## Hatchet Ridge Wind, LLC

RE: Technical Information and Recommended Responses to Comments Suggesting Moving Turbines to Address Visual Impacts

RE: Technical Information and Responses to PUC Comments

RE: Technical Information and Recommended Responses to CADFG Comments

**Figure 1.** View looking West from Burney (current proposed MWT95 2.4 MW Layout)

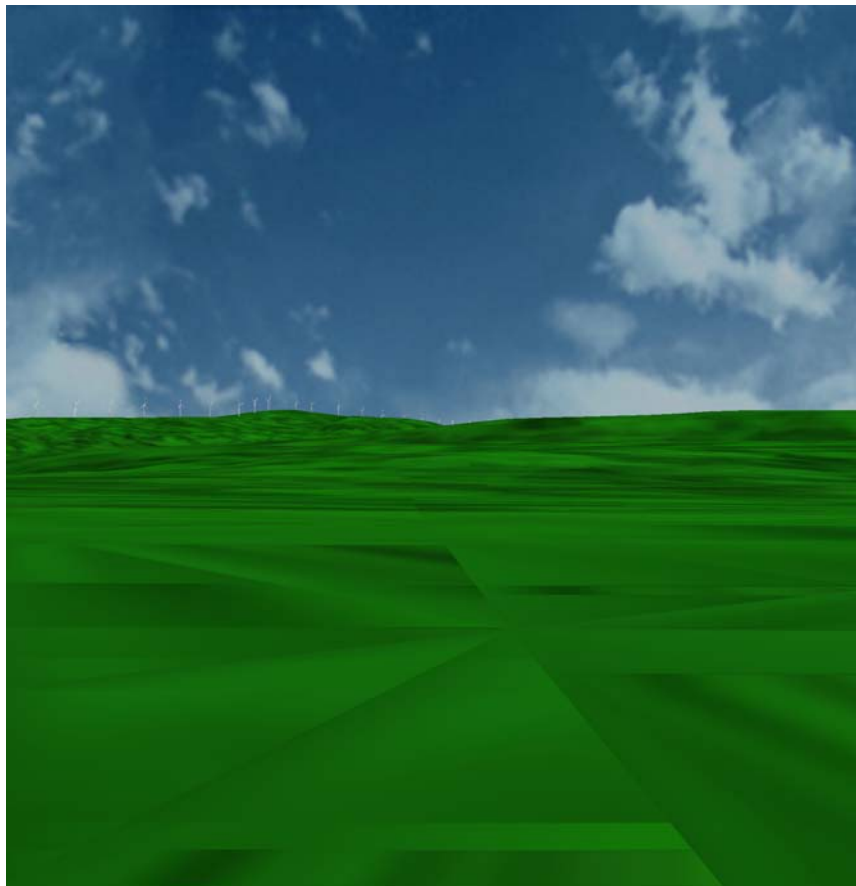
Per the request of Shasta County for the Project Applicant of the Hatchet Ridge Wind Project to come up with a site plan that would eliminate views of the Project from the town of Burney, Babcock and Brown, LP meteorological and technical team (B&B) has; 1) investigated the zone of visual influence (ZVI) for the town of Burney, CA using the proposed Hatchet Ridge Project turbine layout and 2) calculated the production that would occur from relocating the turbines. Based upon the proposed site plan of forty three 2.4 MW MHI turbines mounted on 80 meter towers, as shown on Figure 1, many of the turbines are visible on the ridgeline when viewed from the Burney area looking west.

**Figure 2.** Hatchet Ridge Project current proposed layout with no impact on Burney.

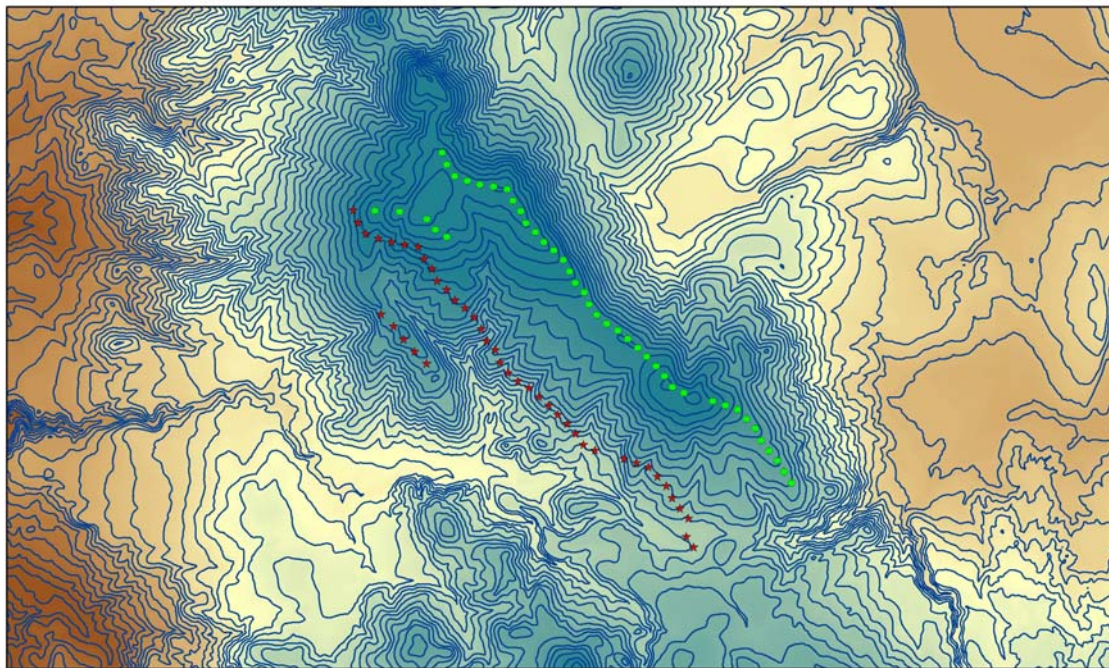
To remove the turbines from the Burney area zone of visual influence, B&B performed a ZVI turbine location analysis that would eliminate all views of turbines from Burney. To achieve this goal, all turbines would have to be moved southwest approximately one mile and off the main ridgeline. Figure 2 shows a map of the current proposed layout (green dots), and the new layout with the turbines off the ridgeline and longer visible from Burney (red stars).
